INDESIT company

Model type:
ARTXF129EU

Commercial code:
F060607

1260310 Exploded views

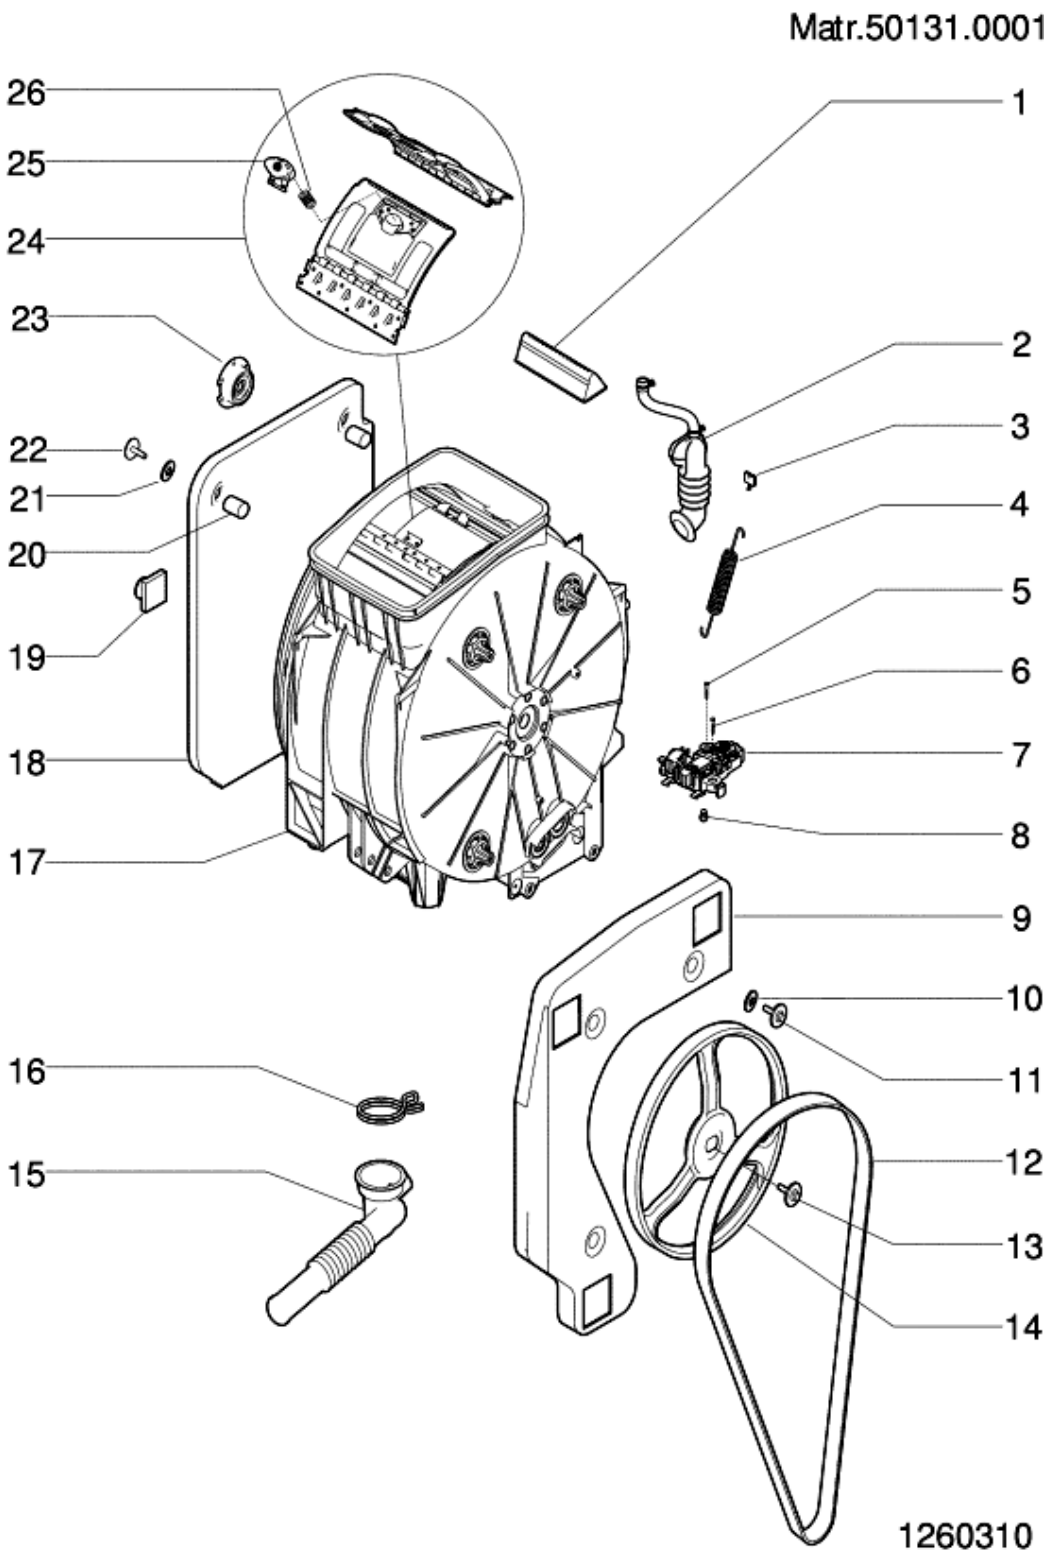
n4009a02: Motor fixing changed on Top Loading washing machines

Top Loading washing machines have changed the fix of motor to the tub.
The tub design is changed in the motor fixing side and two new screws code C00268497 are introduced instead of the old screws C00084333 and the old nut:

C00266015 nut of products with Triphase motor;

C00258673 nut of products with Collector motor.

Spare parts warehouse will go on to manage only the new tubs with the same spare part codes:

C00111505 - Tub 600/1000 rpm

C00111573 - Tub 1200 rpm

C00252343 - Tub 1400 rpm

In assistance on premodification products with the new tubs, you have to fix the motor using the new screws C00268497 instead of the screws and nut that you find in the product.

s/n 80818.0001 - all models 1400 rpm Collector and Triphase motor

s/n 80818.0001 - all models 600 – 800 – 1000 – 1200 rpm Triphase motor

s/n 90113.0001 - all models 600 – 800 – 1000 – 1200 rpm Collector motor
